SANDIA REPORT

SAND2014-2647
Unlimited Release
Printed April 2014

Review of Inputs Provided to Jason Associates Corporation in Support of RWEV-REP-001, the *Analysis of Postclosure Groundwater Impacts* Report

Review of Inputs Provided to Jason Associates Corporation in Support of RWEV-REP-001, the *Analysis of Postclosure Groundwater Impacts* Report

Figure 1. Groundwater pumping estimates (in acre-feet) for the Amargosa Desert generated by the State of Nevada, Division of Water Resources between 1983 and 2012.

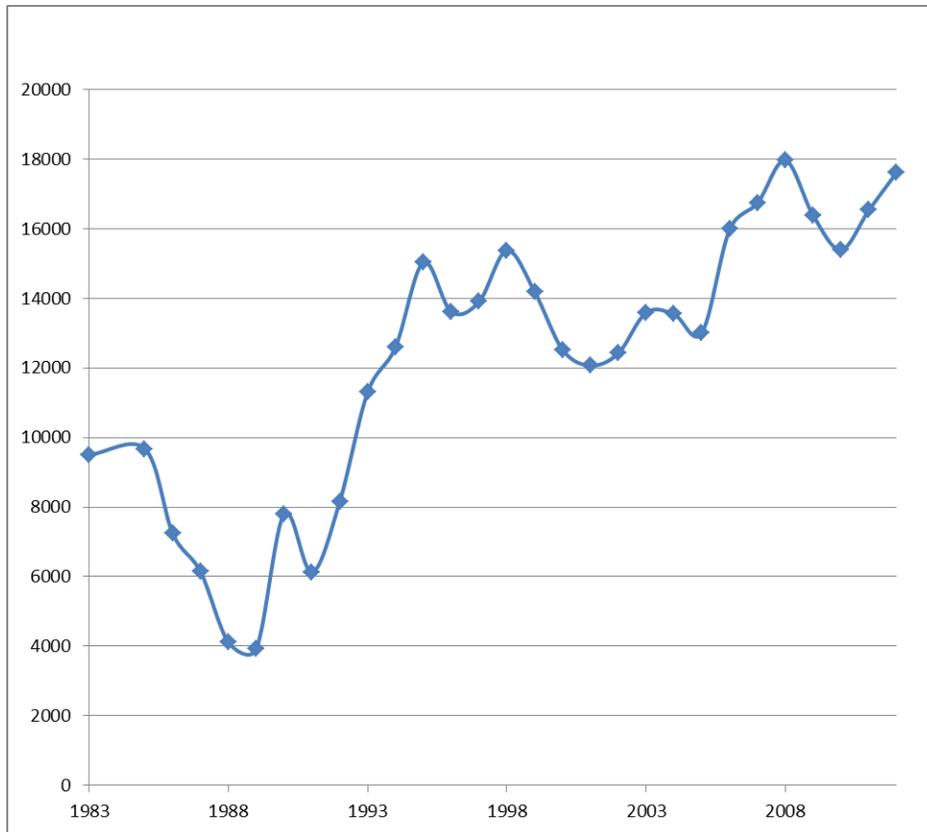
Significant changes in the pumping rates in the Amargosa Valley might have required rerunning the DVRFS, because in the “pumping” scenarios, these pumping rates are used. The pumping rates used in the 2009 report are based on 2003 data. As shown in Table 2-1 of the *Groundwater Impacts* report (DOE 2009a), groundwater pumping in 2003 consisted largely of irrigation-related pumping in the Amargosa River section of the Central Death Valley subregion (17,600 acre-feet), while the Fortymile Canyon section (92 acre-feet) and the Funeral Mountains section (55 acre-feet) represented only minor contributions (see Moreo and Justet 2008 [DIRS 185968], database) to the total. In the Southern Death Valley subregion, the only groundwater pumping activity in 2003 was in the Shoshone-Tecopa section (27 acre-feet, including pumpage from the California Valley section; see, Moreo and Justet 2008 [DIRS 185968], database).

The 2009 *Groundwater Impacts* report DVRFS calculations used total groundwater pumping rates for the Amargosa Valley of 14,100–21,200 acre-feet per year from 1994 to 2003, averaging 16,800 acre-feet per year. These data are based on USGS estimates of groundwater withdrawal in the Valley. While more recent estimates of pumping rates by the USGS have not been published, the State of Nevada, Division of Water Resources (NVDWR) has published additional data (see, Amargosa Valley No. 230, <http://water.nv.gov/data/pumpage/?basin=230>, last retrieved 3/10/2014); these data are shown in Figure 1. NVDWR estimates of groundwater withdrawal rates from 2006 to 2012 range from 15,400 to 18,000 acre-feet per year, averaging 16,700 acre-feet per year. This value closely matches the value used in the 2009 *Groundwater Impacts* report.

It is important to note that the USGS pumping estimates for the Amargosa Valley have in the past been slightly higher than the groundwater withdrawal rates calculated by the NVDWR, using the same USGS source data but a different approach for estimating irrigation rates in the absence of data (see RWEV-REP-001, p. 2-16). However, since the State of Nevada data constitute the only available data for the post-2003 period, they are appropriate for use to validate the range used in the 2009 report. On the basis of this comparison, there is no need to update the DVRFS modeling done in the *Groundwater Impacts* report to capture more recent pumping data.
